ONE 90 (PREVIOUSLY WATERS TECHNOLOGY PARK )  
PA 18-013 MODIFICATION SUBMITTAL :  
ISSUE DATE: 10-13-20

PA MODIFICATION - INTENT AND DESCRIPTION:  
To review and approve architectural building related design modifications made during plan check for code compliance and constructibility.

PA MODIFICATION COBALT- BLOCKS REVISIONS SUMMARY

PA MODIFICATION - INDIGO ROWS REVISIONS SUMMARY

THIRD LEVEL PLAN

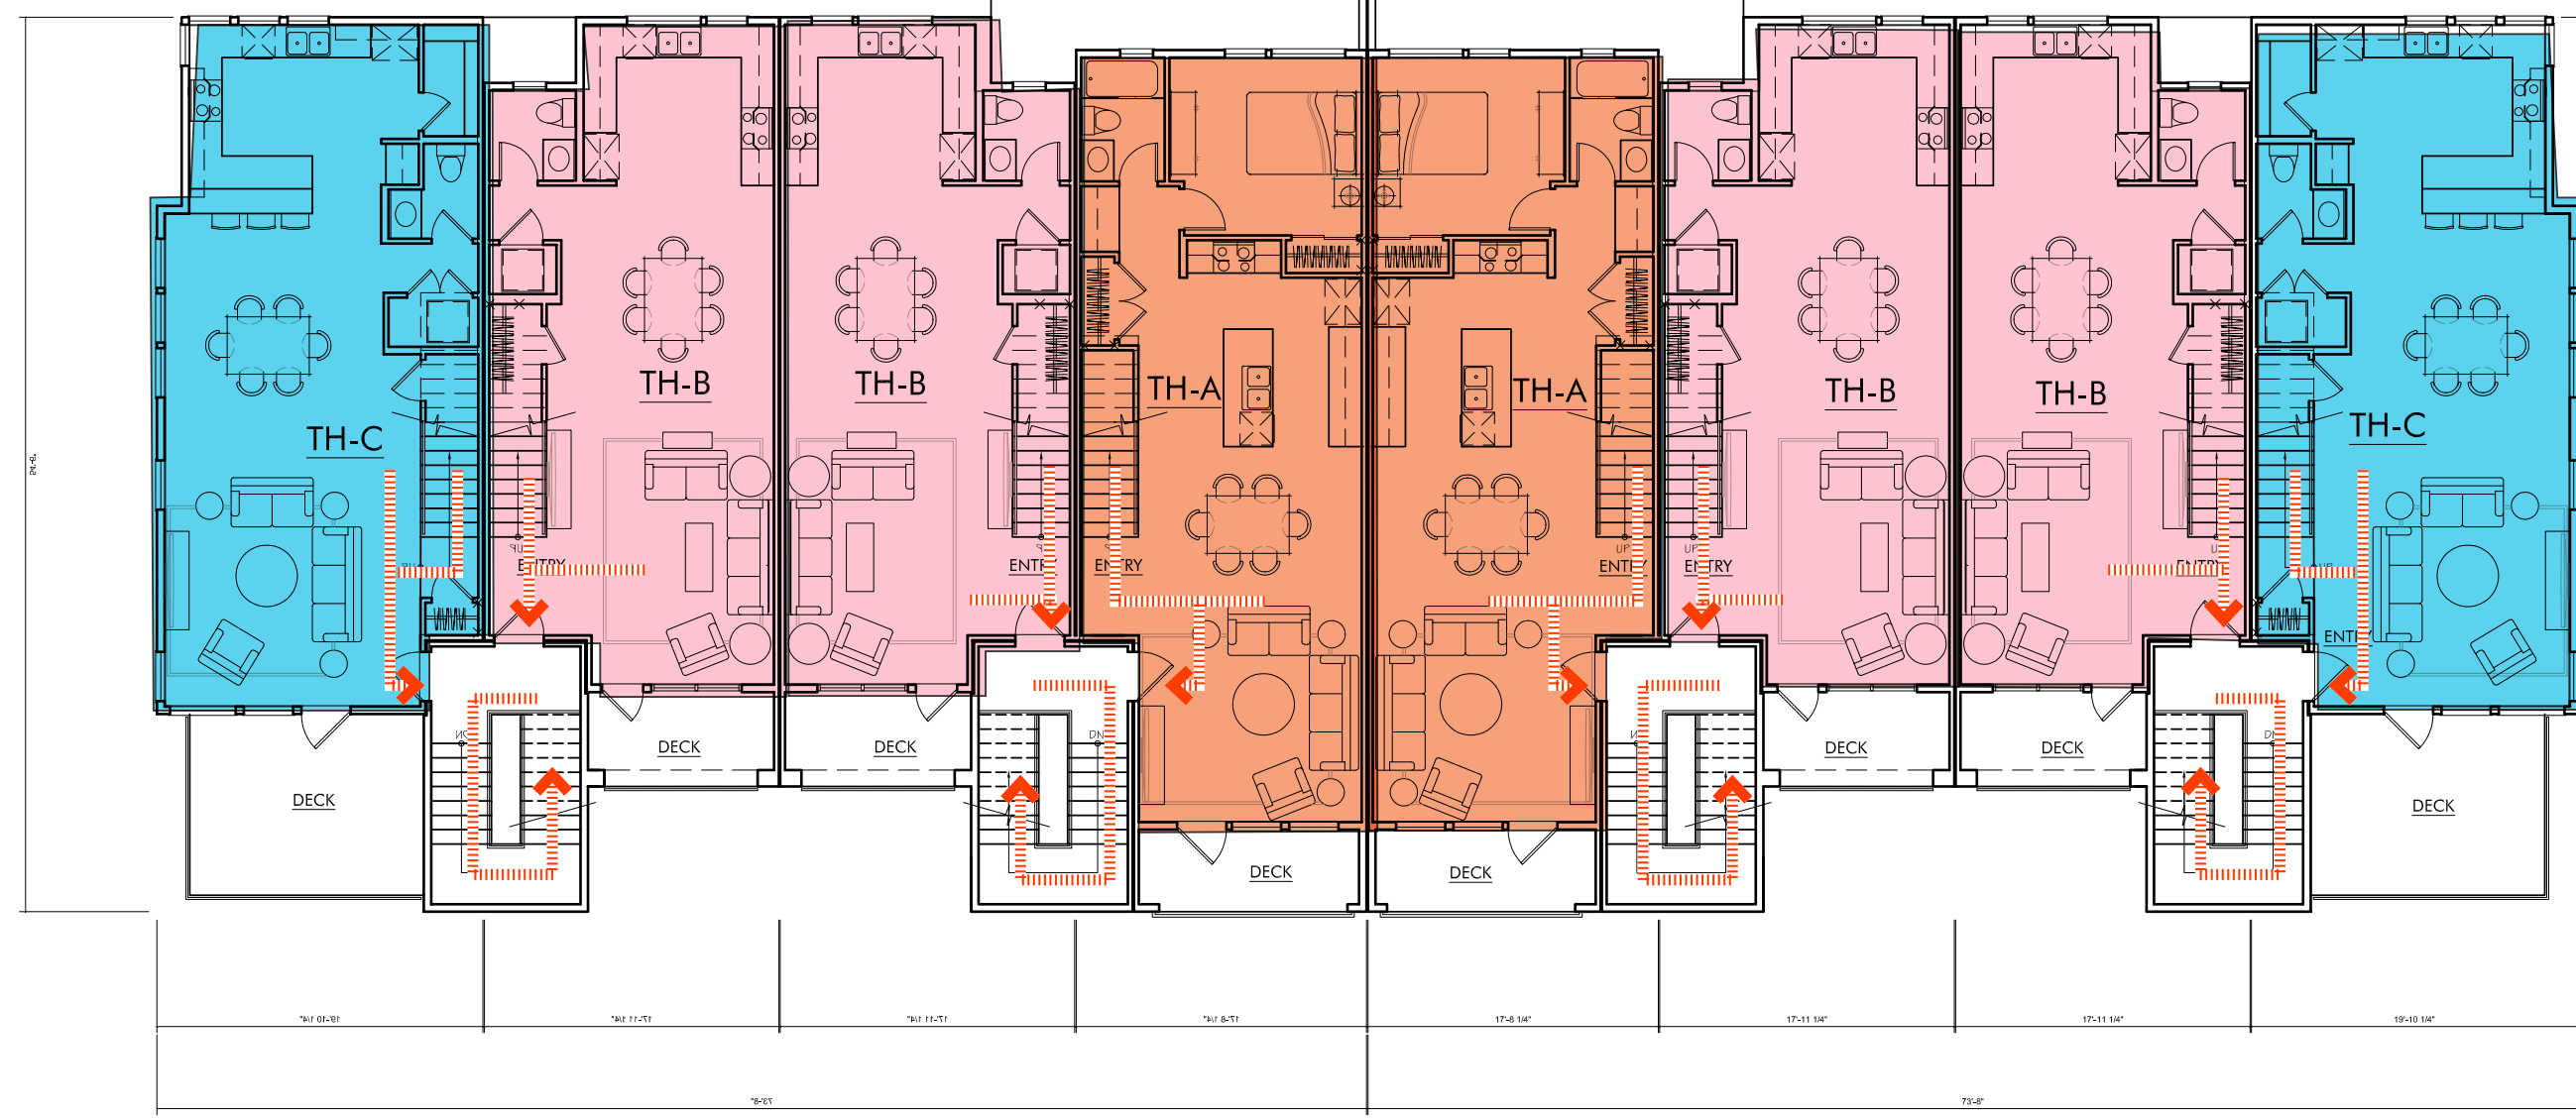
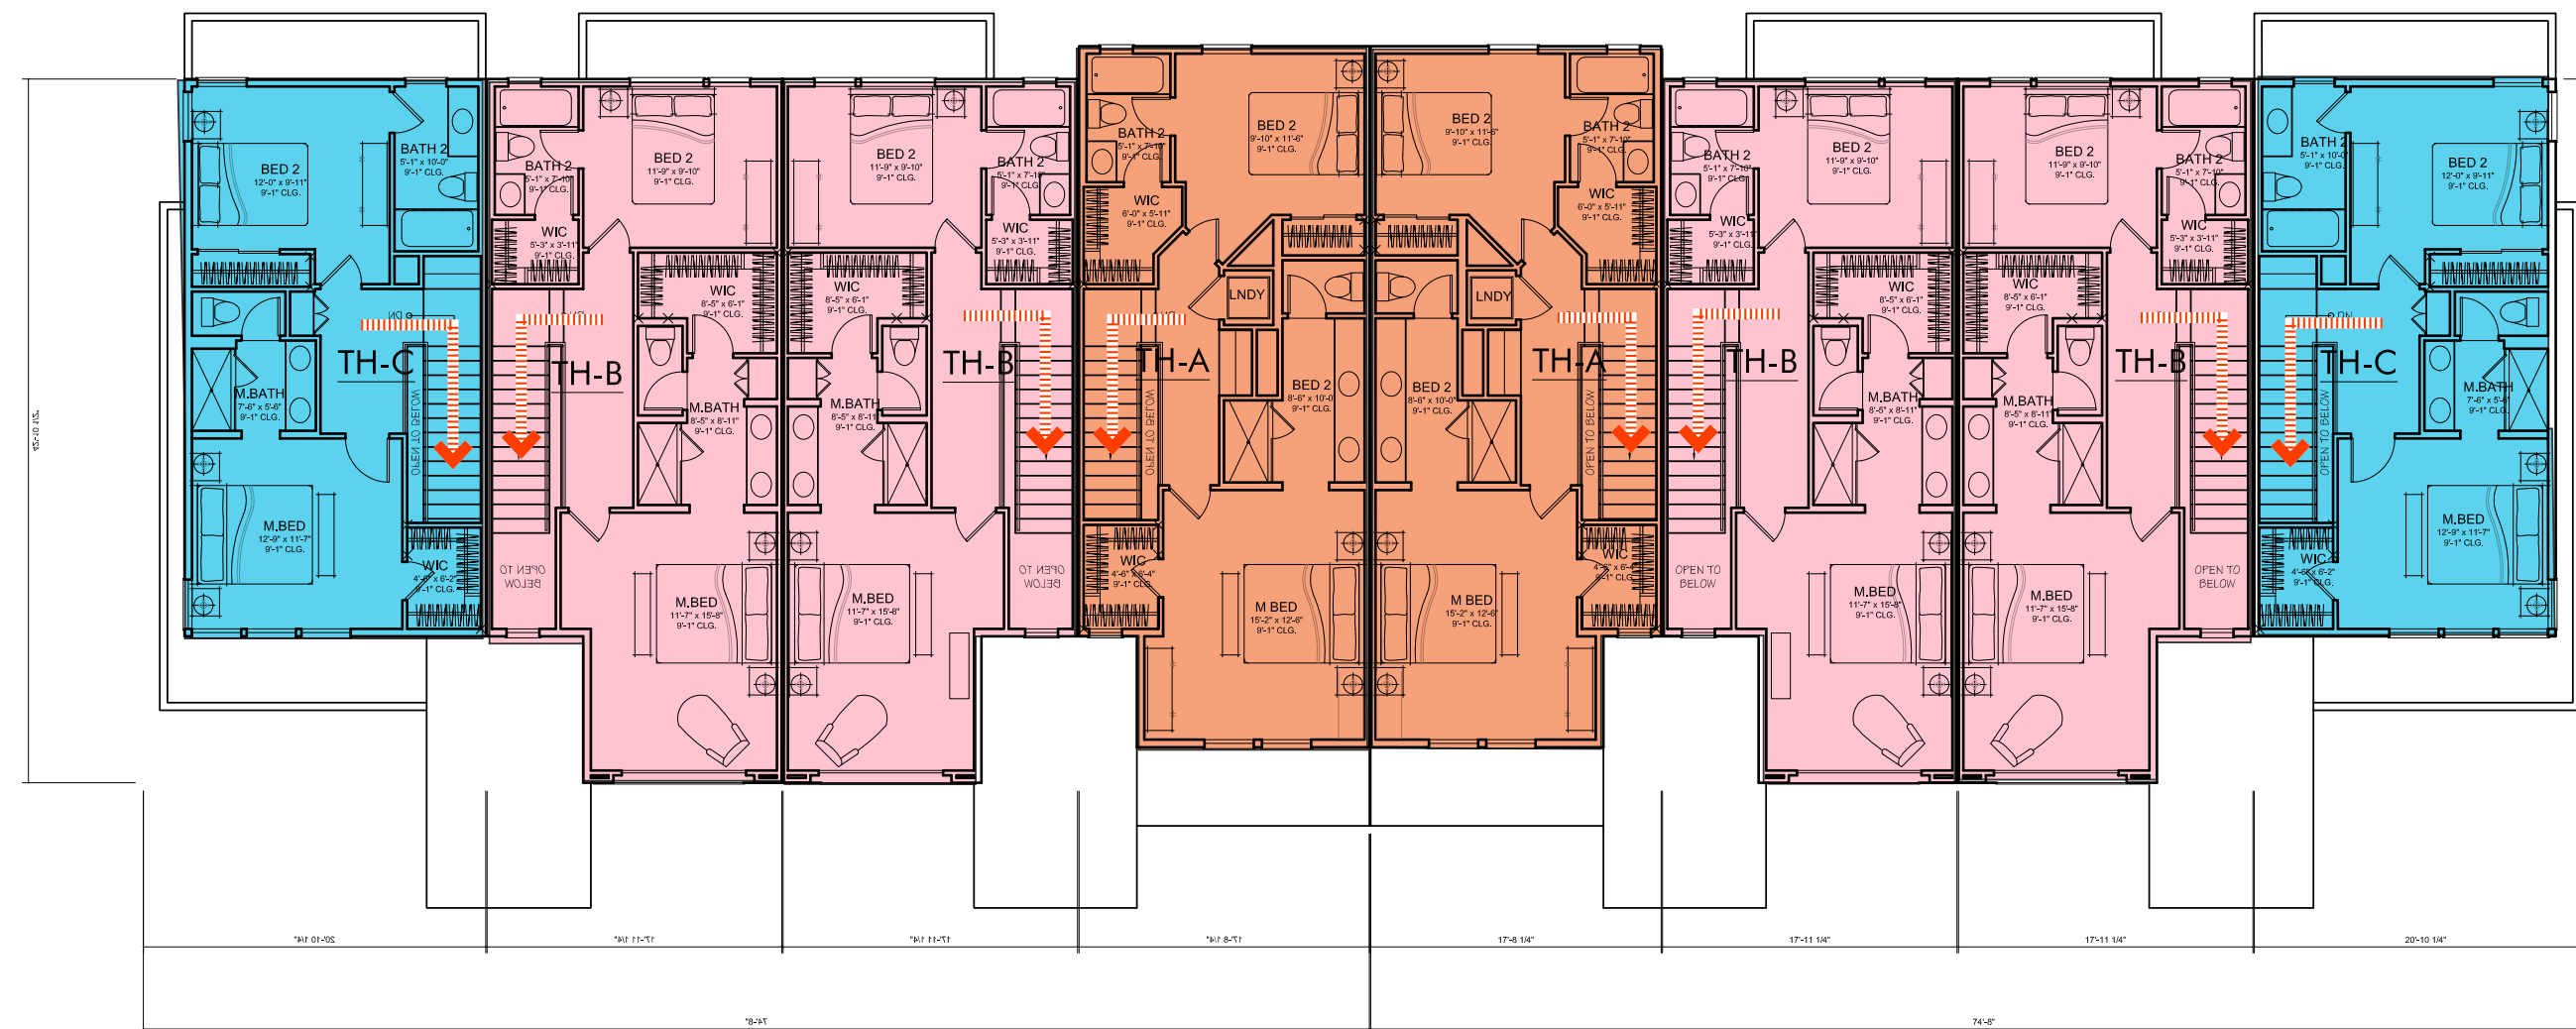
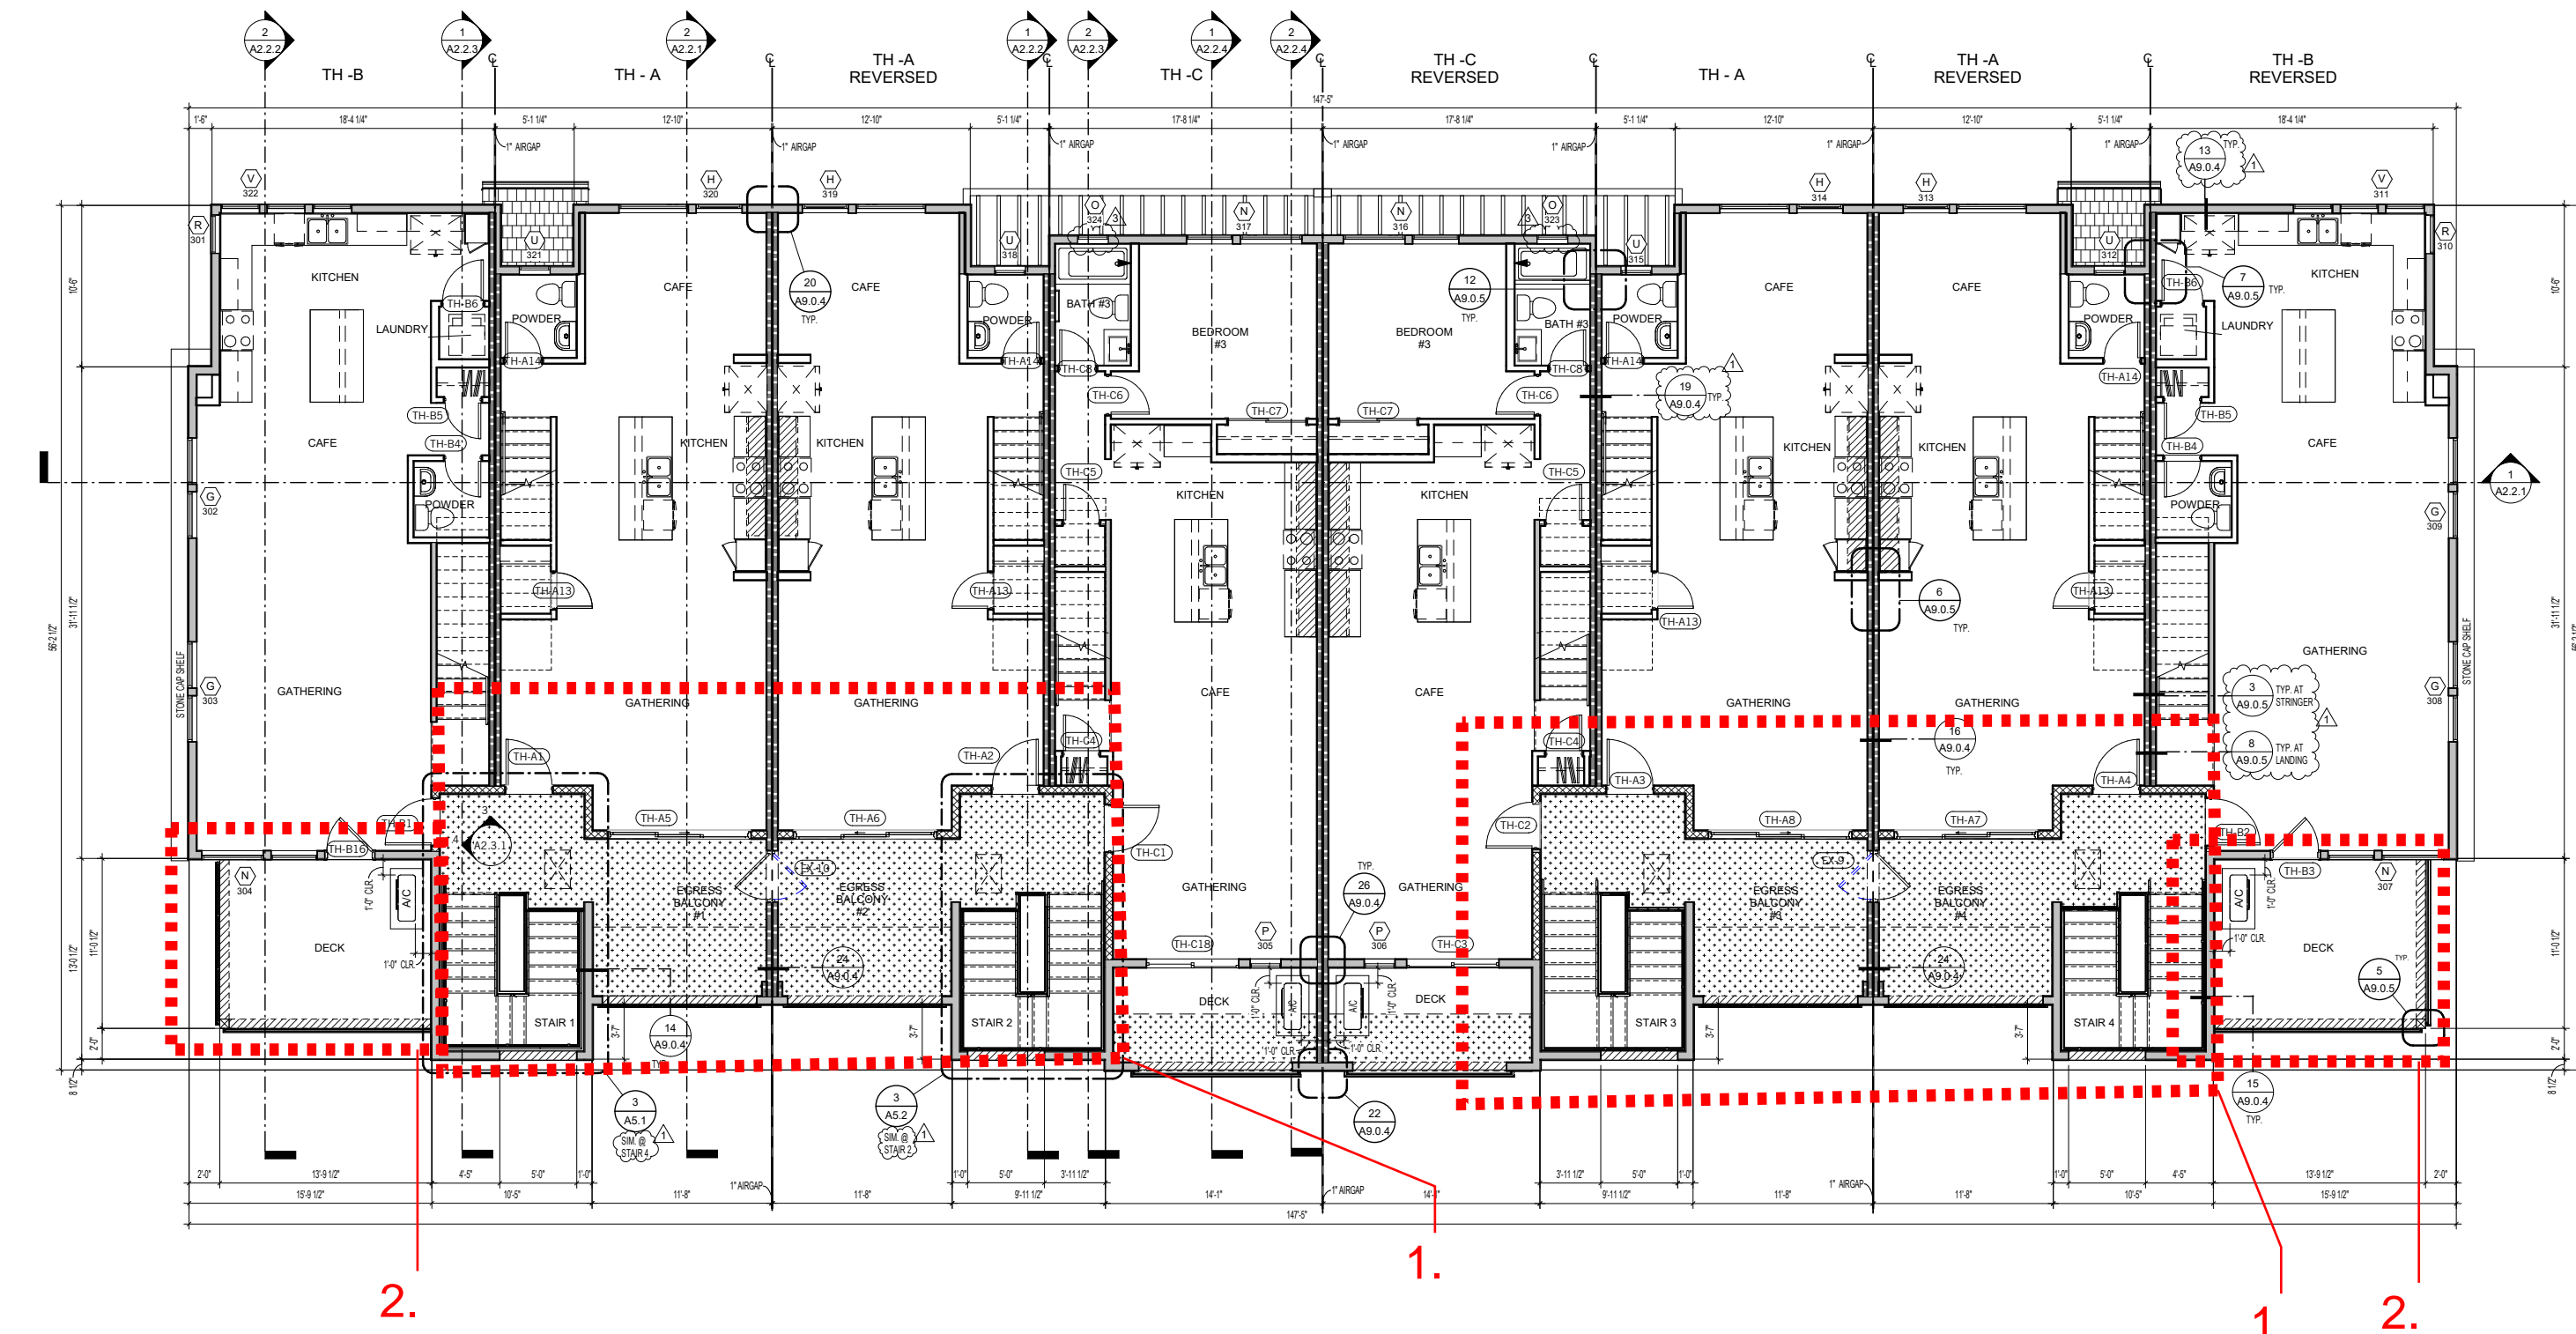
1. Egress balcony at third floor connecting two exit stairs.
2. Enclosed balcony with Flat roof ILO trellis to prevent water intrusion in unit below.
3. Added private balcony on fourth floor for TH units since these units lost their private balcony on third floor to Egress balcony
